APPLICANT(S) : Maria PALASIS
SERIAL NO. : 09/760,807
FILING DATE : January 17, 2001
FOR : THERAPEUTIC DELIVERY BALLOON
EXAMINER : Loan H. THANH
GROUP ART UNIT : 3763
CUSTOMER NO. : 23838

**PETITION PURSUANT TO
37 C.F.R. § 1.182 FOR WITHDRAWAL OF AN
ERRANT ELECTION OF SPECIES**

**RESPONSE TO JUNE 15, 2004, FINAL OFFICE ACTION
AND INTERVIEW SUMMARY**

Fig. 16

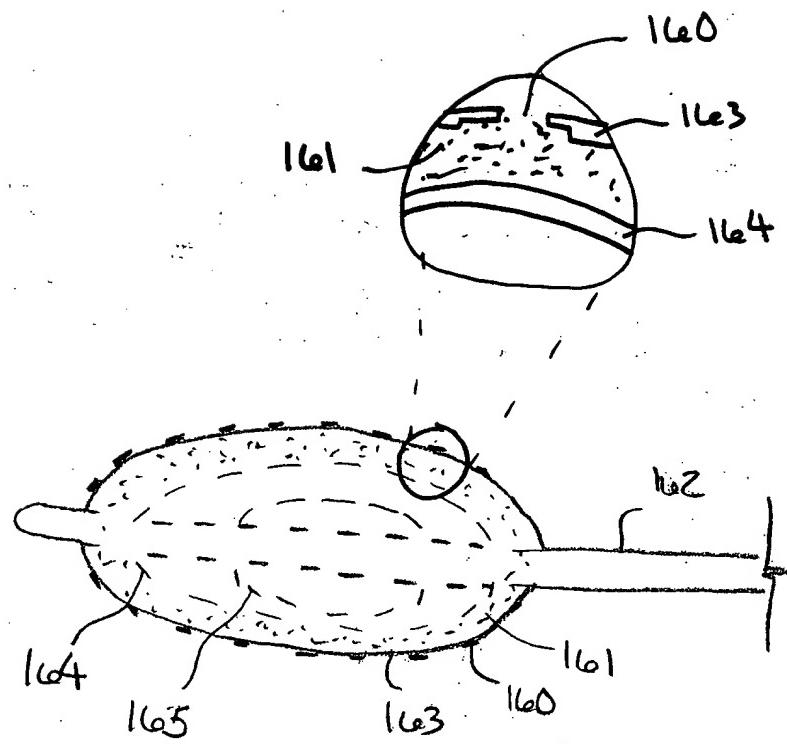
Figure 16 has been amended herein in response to the Office action’s assertion that “the second balloon positioned between the dilation bladder and the first balloon and the grooves in the first balloon must be shown....” The undersigned submits that amended Figure 16, enclosed herein, which now shows the grooves in the first balloon, is not new matter at least for the above reason.

Please replace figure 16 with amended figure 16, which is attached.
